KWM-2/KWM-2A TRANSCEIVERS SERVICE BULLETIN NO 3 (REISSUE)

EQUIPMENT: KWM-2 Transceiver (522-1611-000)
KWM-2A Transceiver (522-1792-000)

SUBJECT: Correlation Between Frequencies on Different Bands

KWM-2 After Modification, Schematic Change

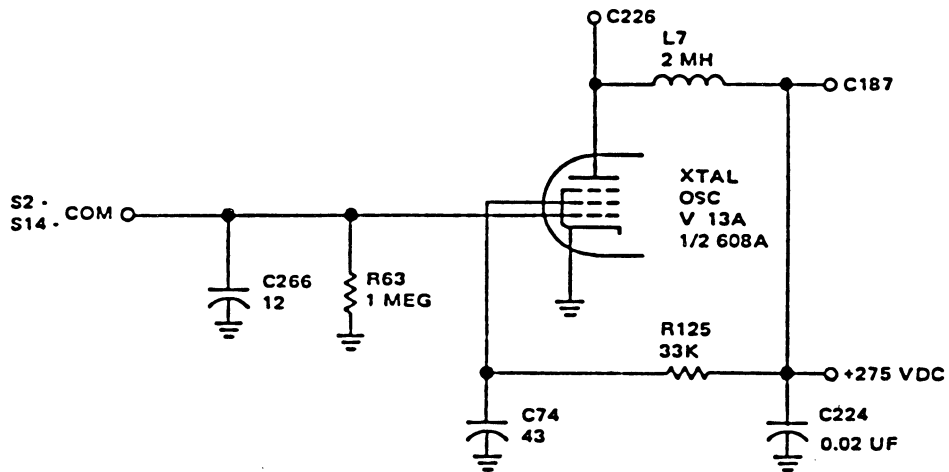
- c. Remove and discard 27-pF capacitor C266, if present, from XV13A pin 2 to the center shield of V13 (ground), and install at this location a 12.0-pF capacitor (912-2757-000), KWM-2 only.
- d. Remove and discard 47-k Ω resistor R125 from XV13A pin 2 to vector terminal board E100, and replace with 33-k Ω resistor (745-1415-000).
- e. Remove and discard 47-pF capacitor C74 from XV13A pin 3 to ground, and replace with 43.0-pF capacitor (912-2789-000).
- f. Inspect unit for damage incurred during modification, dress wires and cables, and remove debris.
- g. Reassemble unit by reversing step a.
- h. Check transceiver for proper operation.
- i. Mark information chart (280-3778-010) SB 3R. Apply chart to convenient location on unit if one is not present.

NOTE:
C266 NOT USED IN KWM-2A.
